March 2, 2021

Re: Second Submission Review – Lone Tree North Phase 2 – Oil & Gas Permit
Application Number: **DA-2093-02**
Case Number: **2017-6027-03**

Option 1 – Drilling and Completions Phases

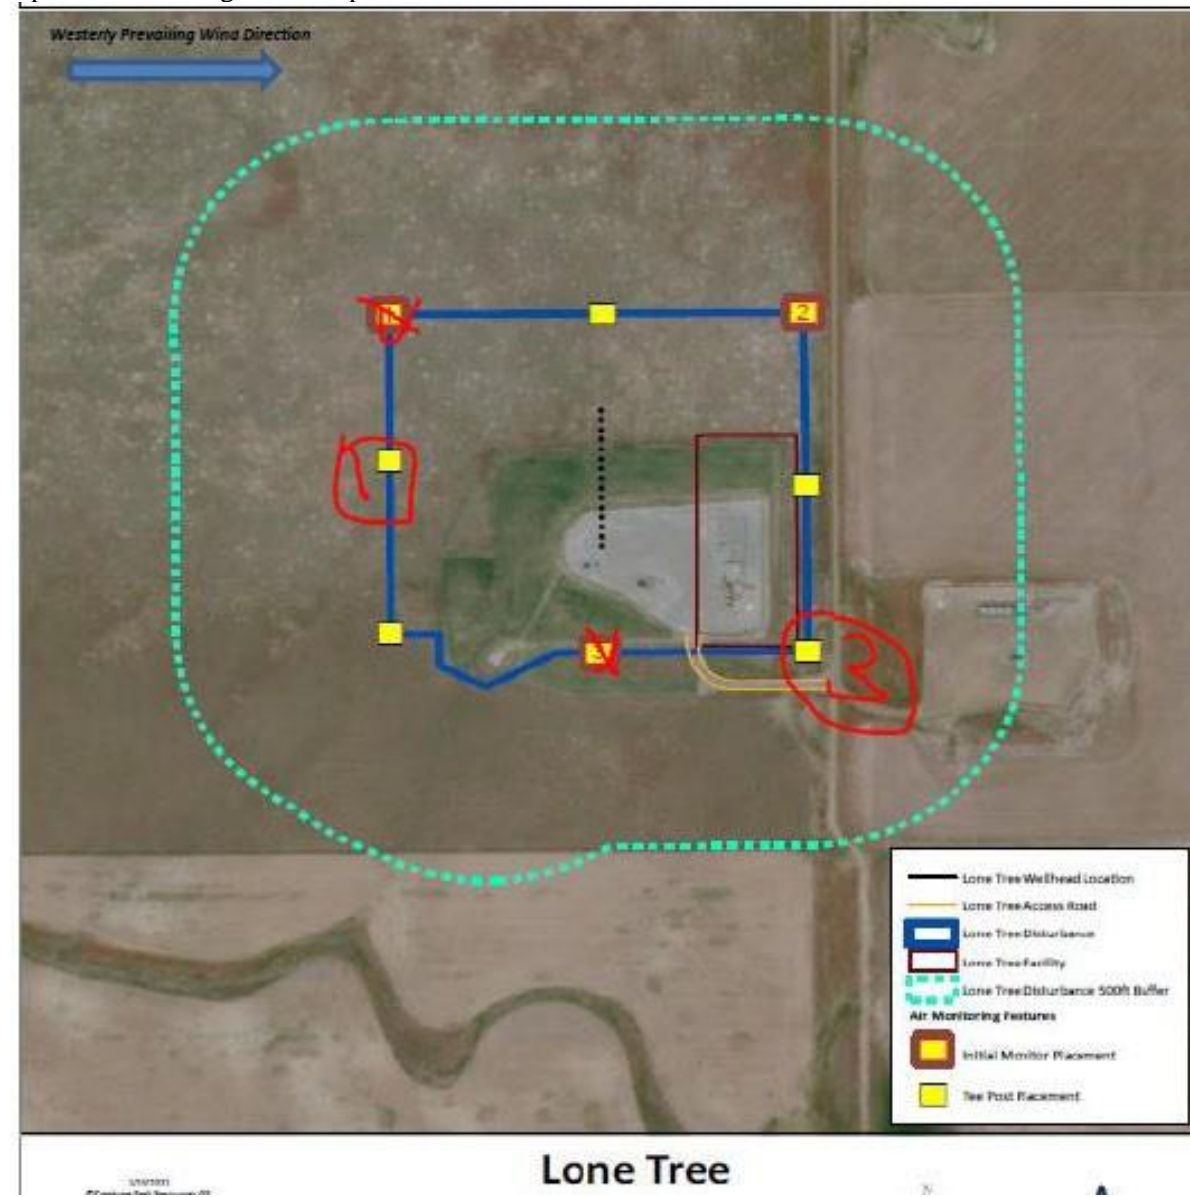
32Q. Monitor Placement comments:

Section 4.3- Roadways should only be a high priority when highly trafficked (i.e. main road) and when the well site is in close proximity. Rather than choosing monitor locations because of the possibility of lots of trucks hauling frac fluids and/or flowback during completions, it is better to choose a longer-period phase; and chosen to consider the main oil and gas processing/storage operations, such as closer to and downwind of the wells and process equipment; and chosen downwind of prevailing winds; therefore preferred 3 stations show below. There are two proposed options for the preferred station locations during different phases of operations. Option 1 is for the drilling and completions phases. Option 2 is for the production phase.

Response: While we understand your rationale for monitor placement, the Applicant believes their proposed monitor placements along with added language further explaining the rationale used to determine these proposed locations is of equal importance and validity and has therefor left the locations unchanged. Please note that these locations are the initial choice of placement and will be moved with the city's consent if data collected indicates more suitable locations.
